**Notice of Meeting for the
Historic and Architectural Review Commission
of the City of Georgetown
August 22, 2019 at 6:00 PM
at Council and Courts Bldg, 101 E 7th Street Georgetown, TX 78626**

Public Hearing and possible action on a request for a Certificate of Appropriateness for an addition to a street facing façades at the property located at 503 E 14th Street, bearing the legal description of Hughes Addition, BLOCK 5 (SW/PT) (2019-42-COA) – Chelsea Irby, Senior Planner

Public Hearing and possible action on a request for a Certificate of Appropriateness for Replacing a Historic Architectural Feature with a Non-Historic Architectural Feature (Siding) at the property located at 1008 S Main Street, bearing the legal description of Lot 2, Block 13 of the Lost Addition (2019-49-COA)
– Chelsea Irby, Senior Planner

South Elevation
"Street View"

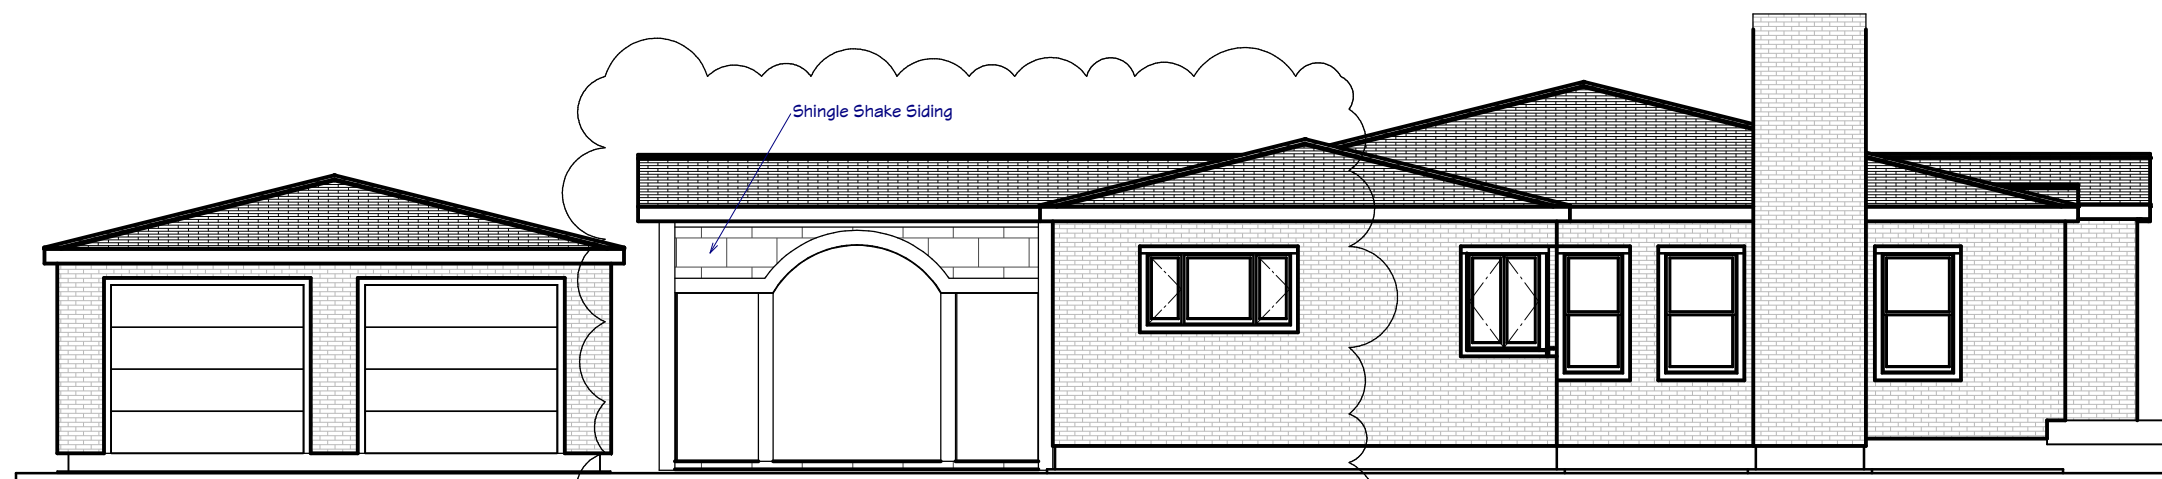
Overall, the proposed addition to the south façade is appropriate because it is located in the rear of the structure, maintains the existing building materials, and has a slight jog in the foundation which helps to create a differentiation. This addition would be adding onto a previous expansion of the original structure. The proposed addition is also compatible in scale. The existing structure is approximately 1,400 sq. ft. The proposed covered patio is 224 sq. ft. and the proposed bathroom addition is 184 sq. ft. The proposed addition will remove a window from existing east façade; however, the window will be re-installed.

Overall, the proposed addition to the south façade is appropriate because it is located in the rear of the structure, maintains the existing building materials, and has a slight jog in the foundation which helps to create a differentiation. This addition would be adding onto a previous expansion of the original structure. The proposed addition is also compatible in scale. The existing structure is approximately 1,400 sq. ft. The proposed covered patio is 224 sq. ft. and the proposed bathroom addition is 184 sq. ft. The proposed addition will remove a window from existing east façade; however, the window will be re-installed.

West Elevation

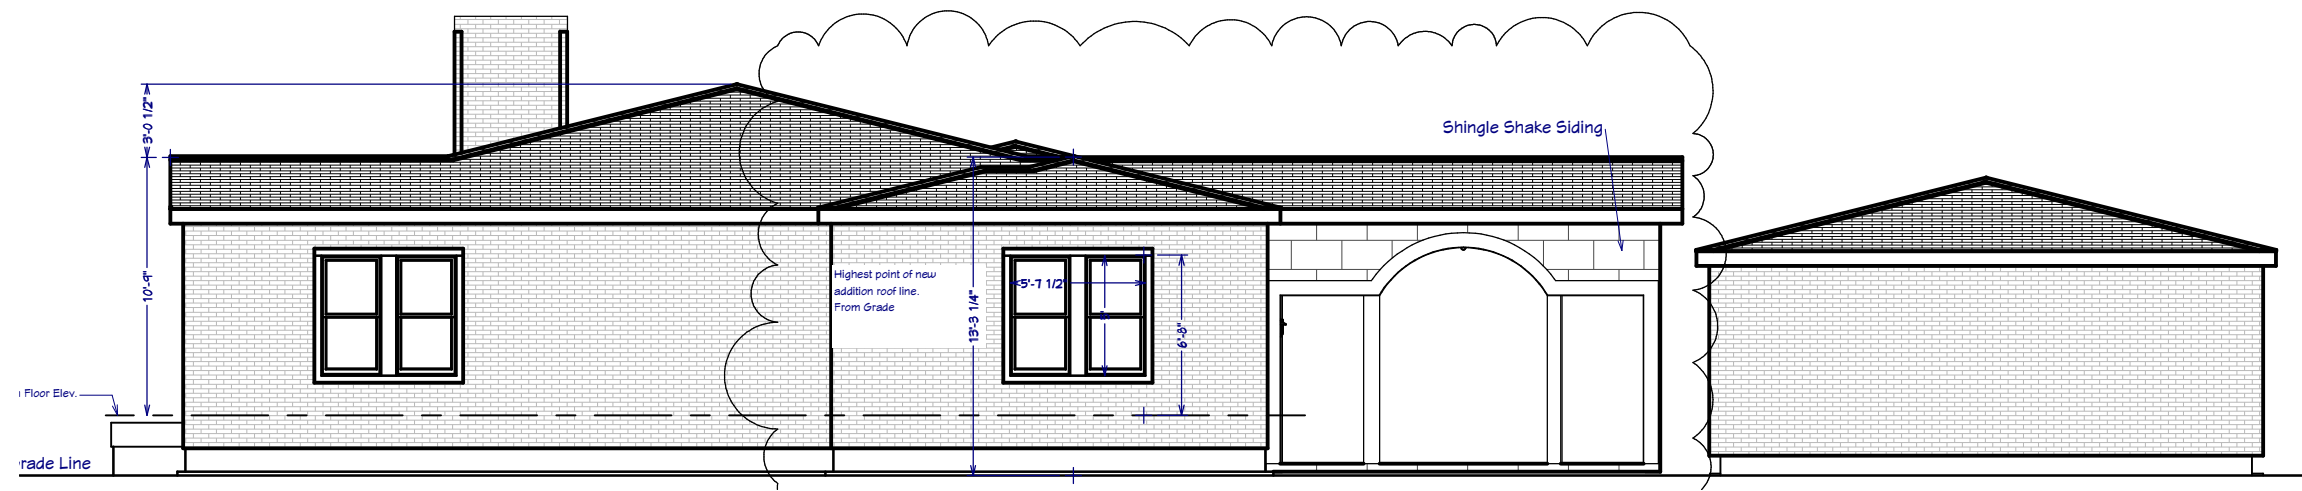
Commissioner Nunn commented that the arch is out of place. She commented that the arch and the use of materials for the siding don't align.

Commissioner Mitchell commented about a design similar to the proposed arch, where the overhang can stay more inline with the roofline and still provide coverage from the sun. The applicant replied that the effect the arch would create as requested by the homeowner deals more with inside the arch and the ceiling coverage.

The addition of the covered porch to the rear of the existing structure respects the original structure in size and scale. To maintain the scale, the roofline is extended – however, this extension does not create differentiation. The Design Guidelines do recommend subtle differentiation, in this instance, the applicant proposes shingle plank siding (Hardiplank) and an arch detail for the covered patio. While these provide the differentiation encouraged by the Design Guidelines, the style is not consistent with Minimal Traditional or the existing building materials.

The addition of the covered porch to the rear of the existing structure respects the original structure in size and scale. To maintain the scale, the roofline is extended – however, this extension does not create differentiation. The Design Guidelines do recommend subtle differentiation, in this instance, the applicant proposes shingle plank siding (Hardiplank) and an arch detail for the covered patio. While these provide the differentiation encouraged by the Design Guidelines, the style is not consistent with Minimal Traditional or the existing building materials.

NEW SIDING SHALL BE
HARDIEPLANK, ASPYRE COLLECTION, ARTISAN V-GROOVE SIDING

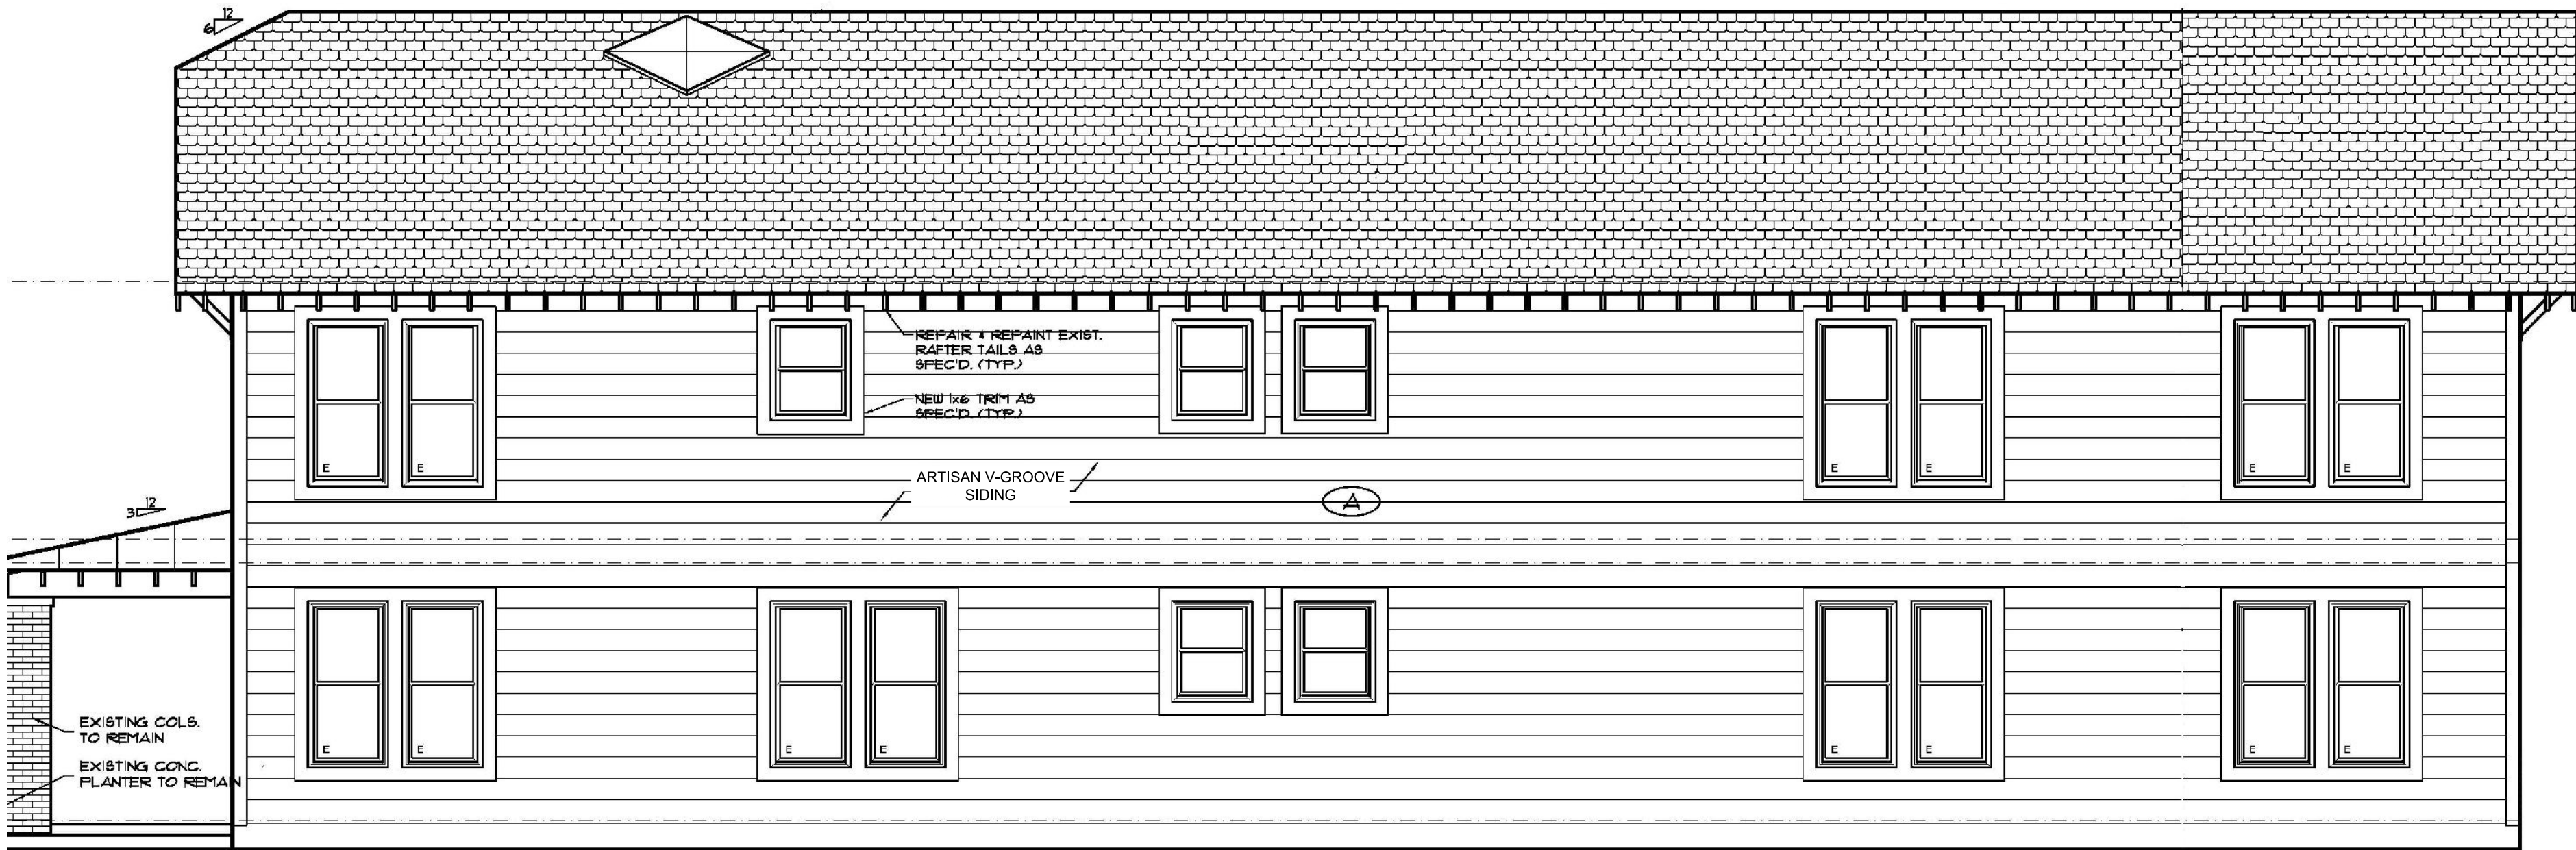
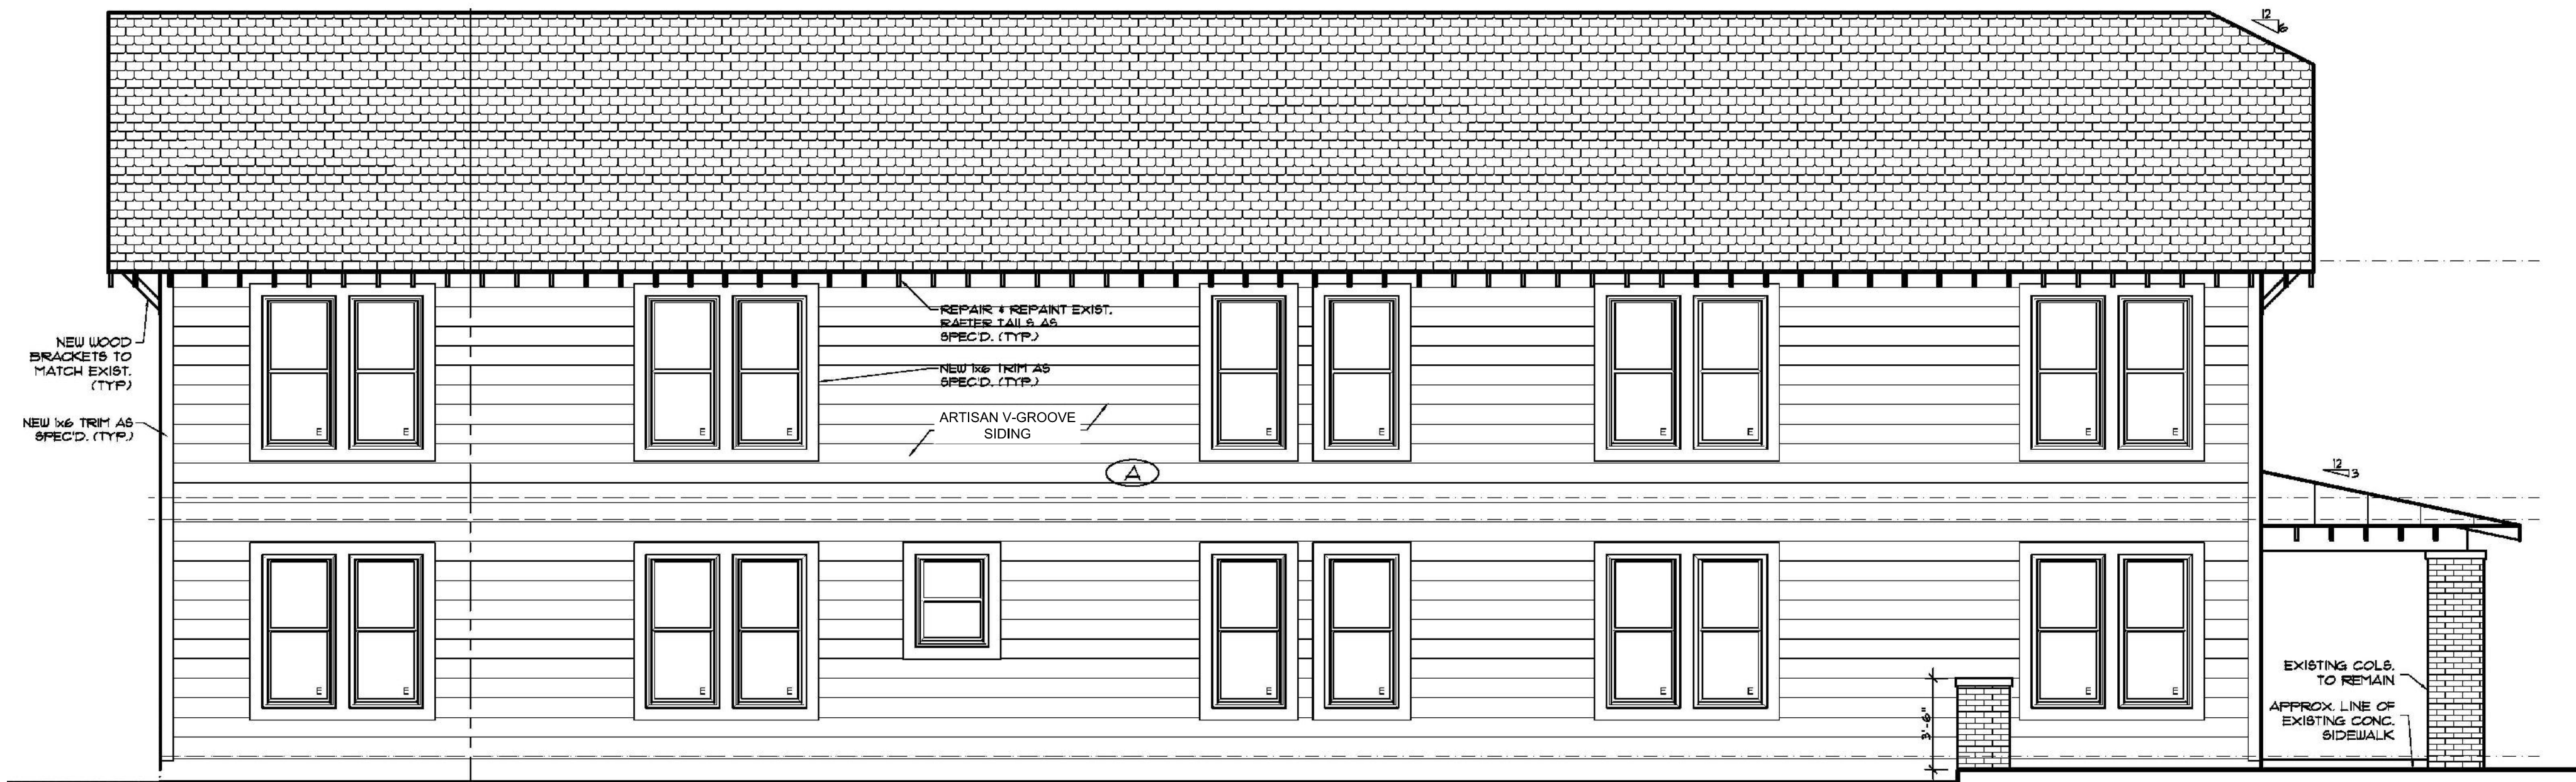
The proposed replacement siding is Hardieplank v-groove lock joint siding of the same width as the original wood. The v-groove lock joint matches the profile of the original wood and would be an appropriate in-kind replacement.

<p>material, and the result will match all visual aspects, including form, color, and workmanship in order to retain the original design of the structure.”</p> <p>The Chief Building Inspector has reviewed the proposed Hardieplank product and finds that it has the same profile, including width and v-groove lock joint.</p>
<p>5.2 Repair deteriorated primary building materials by patching, piecing-in, consolidating, or otherwise reinforcing the materials.</p> <ul style="list-style-type: none">• Avoid the removal of damaged materials that can be repaired.• Isolated areas of damage may be stabilized or fixed, using consolidants. Epoxies and resins may be considered for wood repair. Also, special masonry repair components may be used.	<p>Does Not Comply</p> <p>The applicant is proposing the replacement of all the existing wood siding, rather than repair and maintenance.</p>
<p>5.04 Match the original material in composition, scale and finish when replacing it on a primary surface.</p> <ul style="list-style-type: none">• If the original material is wood clapboard, for example, then the replacement material should be wood as well. It should match the original in size, the amount of exposed lap, and finish.• Replace only the amount required. If a few boards are damaged beyond repair, then only replace them and not the entire wall.	<p>Partially Complies</p> <p>The proposed Hardieplank product has the same profile, including width and v-groove lock joint. However, the applicant is proposing to replace all of the wood siding and the Design Guidelines encourage partial replacement.</p>

<p>5.05 Do not use synthetic materials, such as aluminum, vinyl siding, or panelized brick, as replacements for primary building materials on an historic structure.</p> <ul style="list-style-type: none">• Primary building materials such as wood siding and brick may not be replaced with synthetic materials.• See also Preservation Briefs #16: The Use of Substitute Materials on Historic Building Exteriors, published by the National Park Service.	<p>Partially Complies</p> <p>Hardieplank is a synthetic material. However, the proposed Hardieplank product has the same profile, including width and v-groove lock joint. This would be an acceptable in-kind material replacement, per the UDC and Chief Building Inspector.</p>
